NUMBER: S.I. M20-65

DATE: 2-24-83

SUBJECT: SYMBOLIC DISPLAYS INC., (S.D.I.) FT-101 FUEL FLOW MEASURING SYSTEM, MOONEY M20J and M20K

MODELS/S/N AFFECTED: Mooney Model M20K, S/N 25-0001 & ON, M20J, S/N 24-0001 & ON with FT-101 system installed.

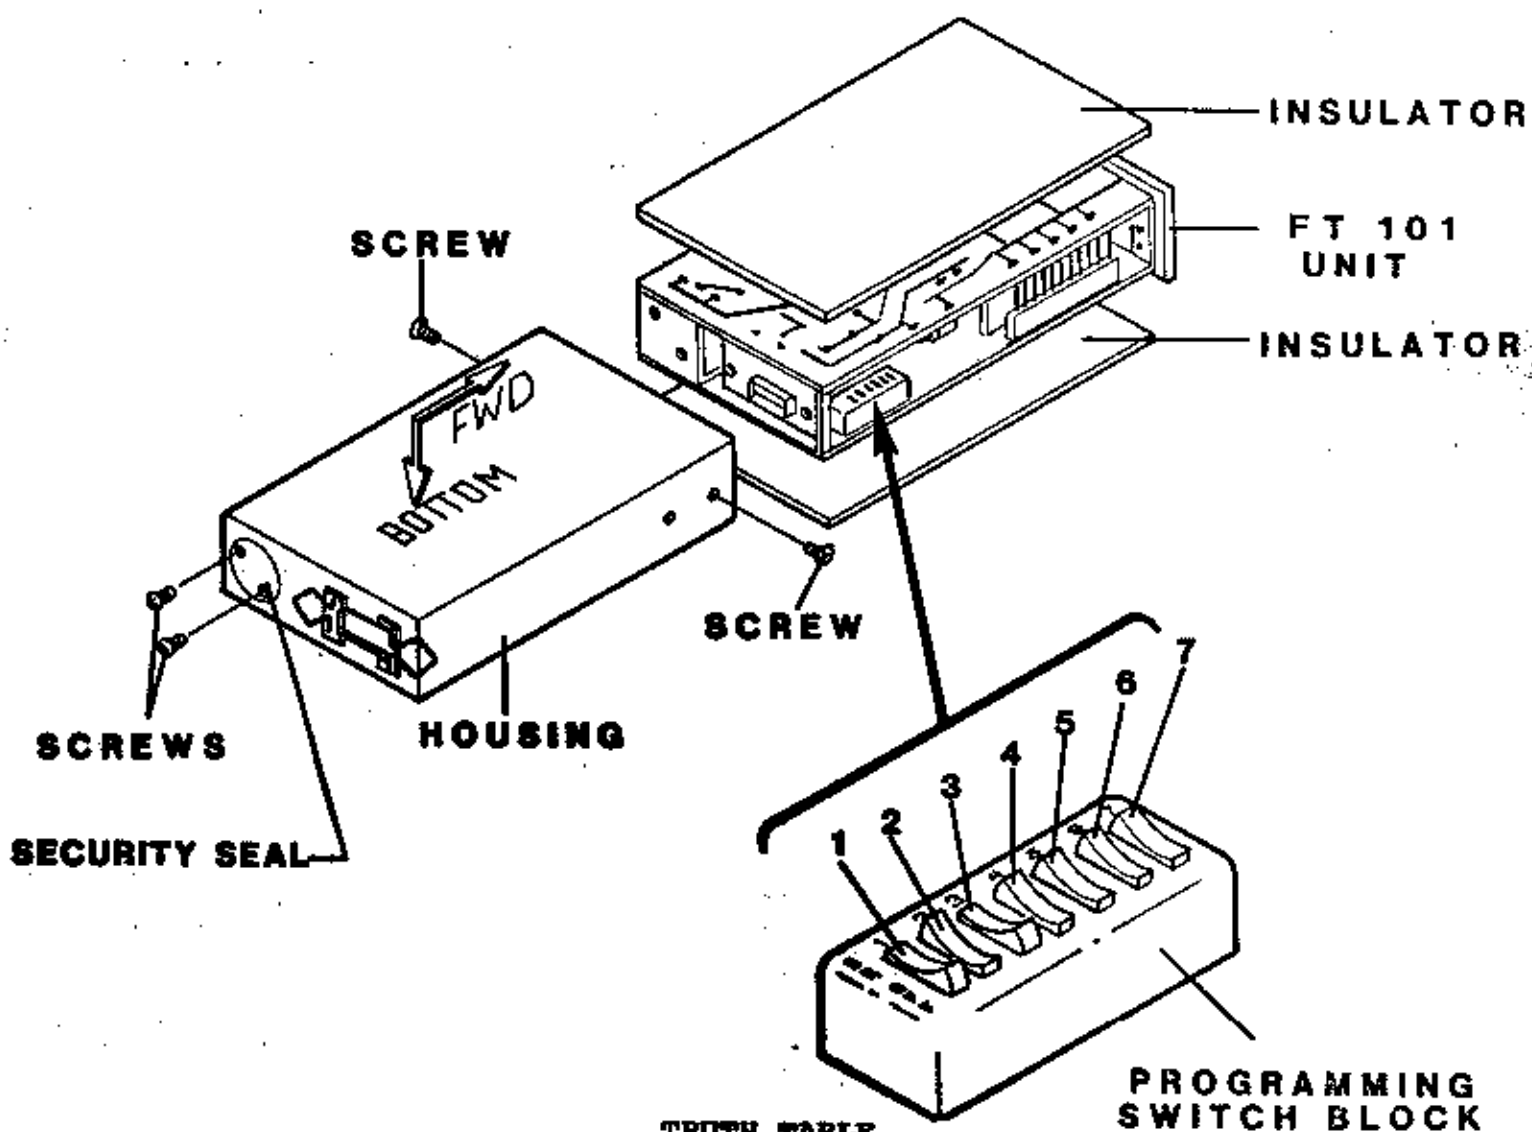
TRUTH TABLE

K-FACTOR	S1	S2	FUNCTION	S3	S4	S5	S6	S7
L	ON	ON	GALLONS	ON	OFF	OFF	NA	NA
M	ON	OFF	POUNDS	OFF	ON	OFF	NA	NA
H	OFF	ON	LITERS	OFF	OFF	ON	NA	NA
HH	OFF	OFF					NA	NA

TRANSDUCERS ARE CATEGORIZED BY THE NUMBER OF PULSES PER SECOND OUTPUT FOR A GIVEN GPH FLOW RATE ("K FACTOR"). THIS WILL BE NOTED AS: L, M, H, OR HH SCRIBED ON THE END OF THE SERIAL NO. FOR ACCURATE READINGS, THE FT-101 INTERNAL SWITCHES MUST BE MATCHED TO THE TRANSDUCER. SEE TRUTH TABLE ABOVE.
